620.17901 L01 - v0.3 20180427 Traffic RtS.docx

Mirvac Projects Pty Ltd  
6001 (Bay 6) and 7006 (Bay 7)  
2 Locomotive Street  
Eveleigh NSW 2015

## **Locomotive Workshop Redevelopment | SSD 8157 and SSD 8449 Traffic and Transport Response to Agency Submission**

**Figure 2 Marian Street – Shared Zone**

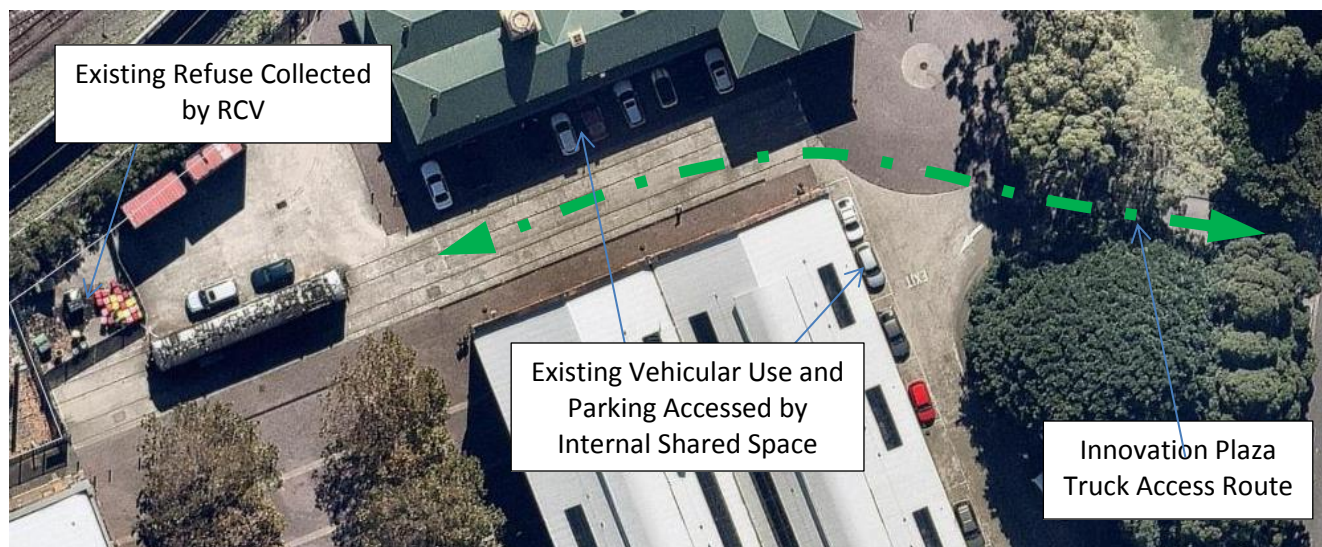
It is acknowledged that the Option 2 route would require trucks to travel through an approximate 90m segment of Marian Street that is currently sign posted as a 10km/h Shared Zone. Approximately 30m of this Shared Zone length relates directly to pedestrian movements travelling between the ATP site and Redfern Station.

Irrespective of the Option 2 truck route being a legal one, it is accepted that the movement should be avoided during periods of high pedestrian utilisation of the Shared Zone like that experienced during the morning and evening commuter peak periods.

In conclusion, and to be categorically clear, Mirvac has a preference for Option 1 although this would require Council to accept and implement changes to the existing kerbside car parking arrangements in Rosehill Street (loss of approximately two spaces). Should Council not accept this Mirvac preferred outcome, the subject development will be serviced via the Option 2 route.
